2023-21006-02

**South East Greenway Linkage
Design - Glenmore**

ROAD SAFETY AUDIT STAGE 1

2.2 Problem

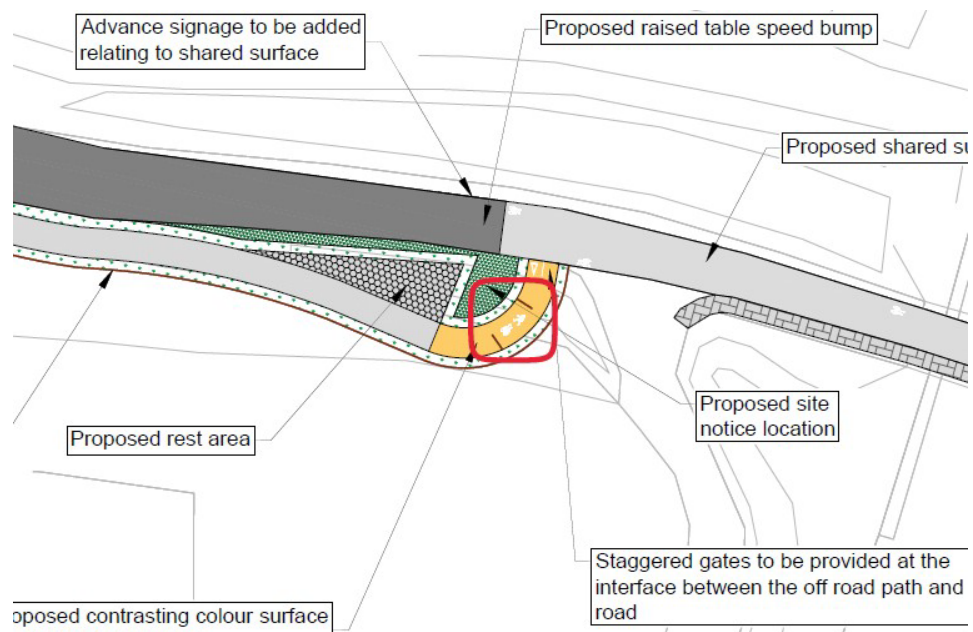
Glenmore village currently has a posted speed limit of 50km/h. This is too high for a shared surface and increases the risk of more serious collisions between motor vehicles and vulnerable road users.

Provide a speed limit of 30km/h on the shared surface and introduce measures to inform drivers that this is an appropriate speed for this section of road.
